# Written Representation for Deadline 5 from Mollett's Partnership (trading as Mollett's Farm)

| Summary of this document's contents:   |
|--|
| This document contains our Deadline 5 submission to the Examining Authority, relating to the Sizewell C development application.   |

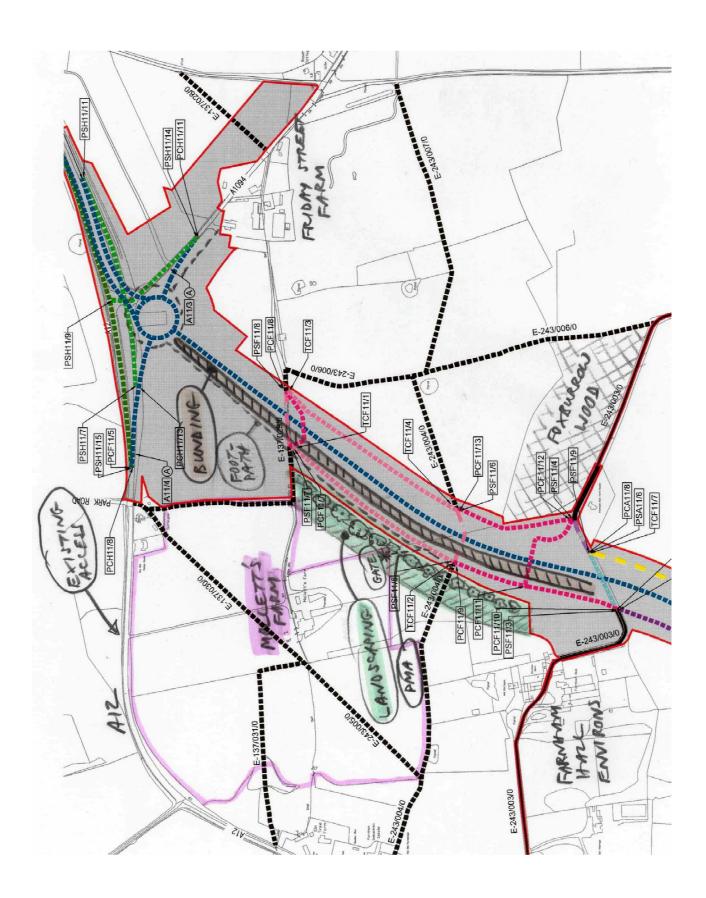
- We need a bund parallel to the route of the TVB that is long enough, high enough and wide enough to screen our business and the parts of our property enjoyed by guests and residents alike from road noise. This is currently absent in the applicant's proposals.

- Suitable visual screening and noise attenuation fencing needs to be incorporated around the eastern TVB contractors' compound during construction and use.

- Upon removal of the eastern TVB contractors' compound, the bunding and noise attenuation fencing needs to be extended up to the Friday Street roundabout and, as necessary, along the existing A12 to protect from traffic noise. This is to protect both us and neighbouring properties in the parish of Benhall (particularly the Old Police House and the two Stockhouse Cottages).

- Revisions to the Public Rights of Way (PRoW) proposals to provide a linear footpath between the walled garden in the Farnham Hall area and the new roundabout at Friday Street.

- Proper crossing points of the relevant arms of the Friday Street roundabout (with splitter islands) to
  enable safe crossing by pedestrians (considering that these may be going to or from relevant
  combinations of Saxmundham, Benhall Green, Benhall Low Street, Farnham, Stratford St. Andrew,
  Mollett's Farm, Farnham Hall, Foxburrow Wood, Greenwood Burial Ground and Friday Street).

- Soft and hard landscaping to absorb the new scar the TVB into its setting, as well as to shield our holiday accommodation, caravan site, camping site and homes from the bund, associated footpaths and private means of access.

- We are willing to have land put into the DCO to achieve a proper solution and have already suggested this in our **Deadline 2 Written Representation [REP2-380]** (a copy of the relevant sketch map is reproduced below).
